CAMPAIGN BULLETIN

Main Harness Routing Dealer Inventory

Reference: PC852

PC852 - 2022 PATHFINDER MAIN HARNESS

Figure 8

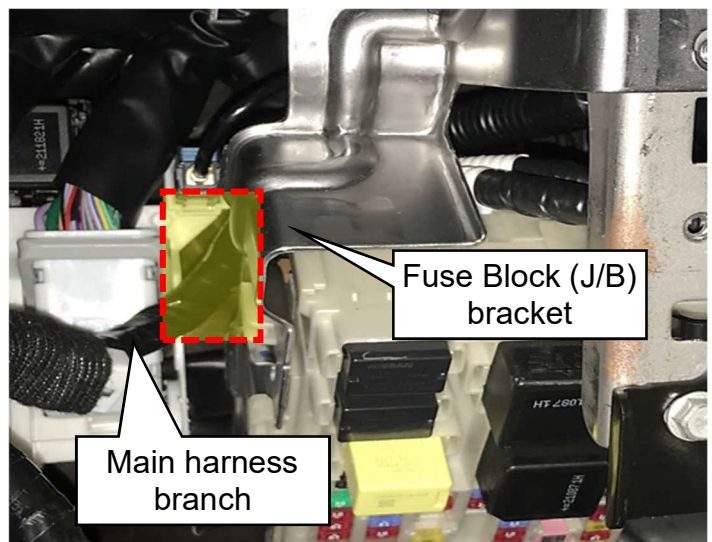
8. Inspect the harness branch shown in Figure 8 for cut (separated) or exposed wires (missing wire insulation, bare wire visible).

Abrasion or damage to the tape of the main harness is OK.

- If there are no cut or exposed wires, continue to **Step 9**.
- If the harness branch has any cut or exposed wires, contact FQA using the information contained in **Step 16** and do not perform any further repairs until a response is received.

Figure 13

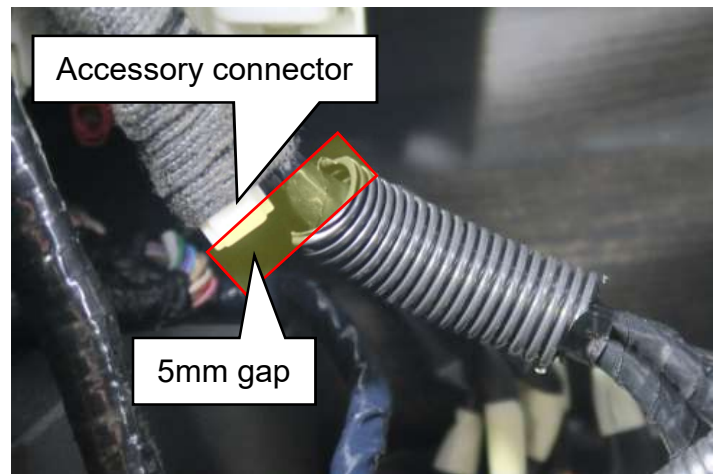
12. Install corrugated tubing (wire conduit) onto the main harness branch.

- Position the corrugated tubing about 5mm below the accessory connector as shown in Figure 13

Figure 14

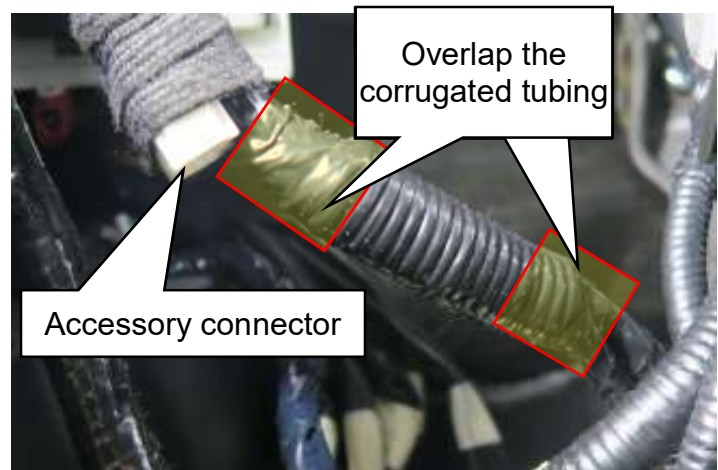
13. Using black electrical tape, secure the corrugated tubing to the main harness branch.

- Completely wrap the corrugated tubing with electrical tape, making sure to overlap the ends to secure it to the main harness branch

Figure 16

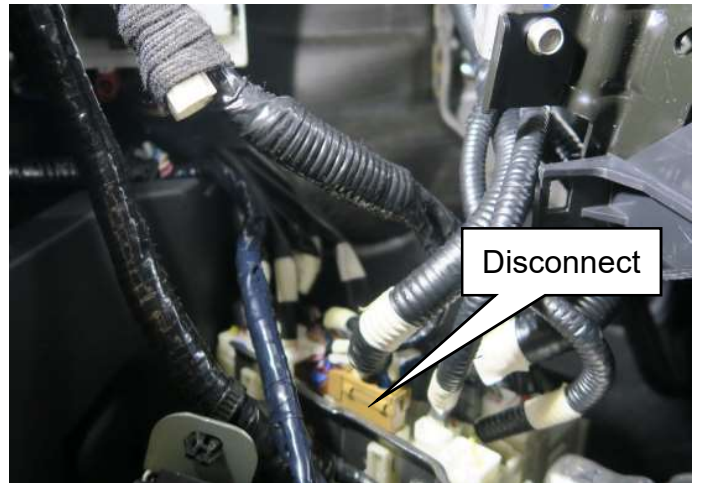
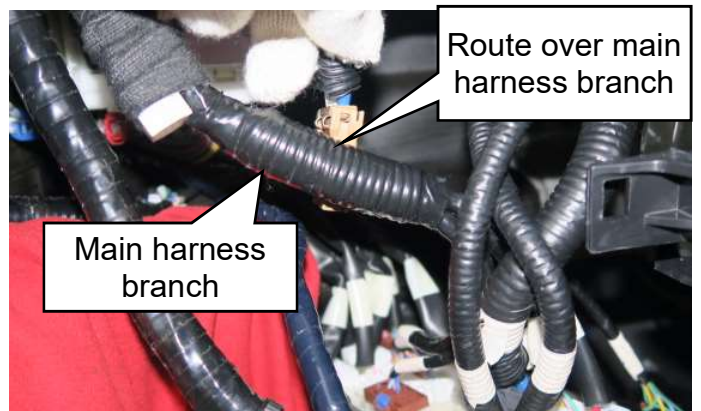
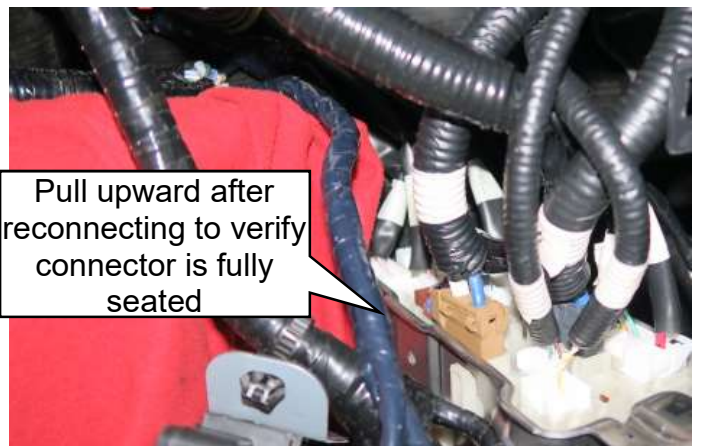
14. Reposition the harness branch.

- Disconnect the brown harness connector from the fuse block. (Figure 15)
- Route the harness over and behind the harness branch as shown in Figure 16
- Reconnect the brown harness connector and pull upward on the harness connector to verify the connector is fully seated in the fuse block (J/B) (Figure 17)
